Report: TAB

Function: Test, Adjust, & Balance

06-23-25 WAWA #6112 FAYETTVILLE, NC

Project: 06-23-25 WAWA #6112 FAYETTEVILLE, NC

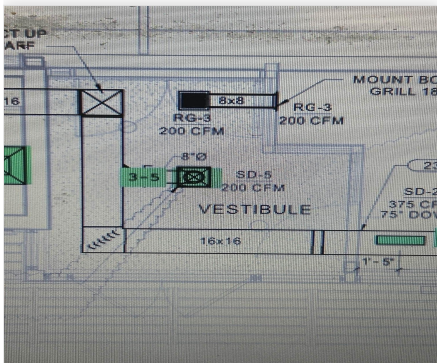
Issue Name : Diffuser damper out of reach
Description : RTU 3 diffuser 3-5 damper out of reach, unable to lower diffuser. Currently sitting at 125% of design.
Created By : National TAB **Assigned To :** National TAB - Brianna Biggs
Status : Open
Priority : Low **Asset Tag :**
Originated Date : 06/24/2025 - Jearod Ferrette - National TAB

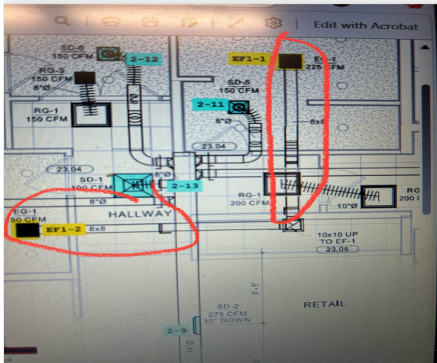
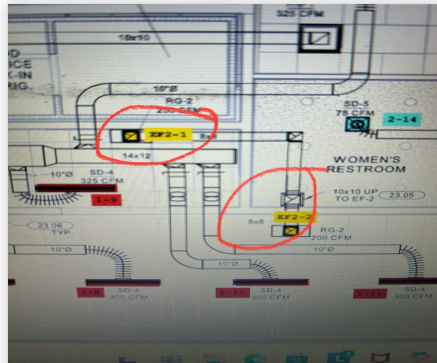
Issue Name : EF 1/2 missing dampers
Description : EF1 (Restroom) and EF2 (Kitchen) are missing dampers. No face dampers.
Created By : National TAB **Assigned To :** National TAB - Brianna Biggs
Status : Open
Priority : Urgent **Asset Tag :** HVAC EQUIPMENT 1
Originated Date : 06/23/2025 - Jearod Ferrette - National TAB
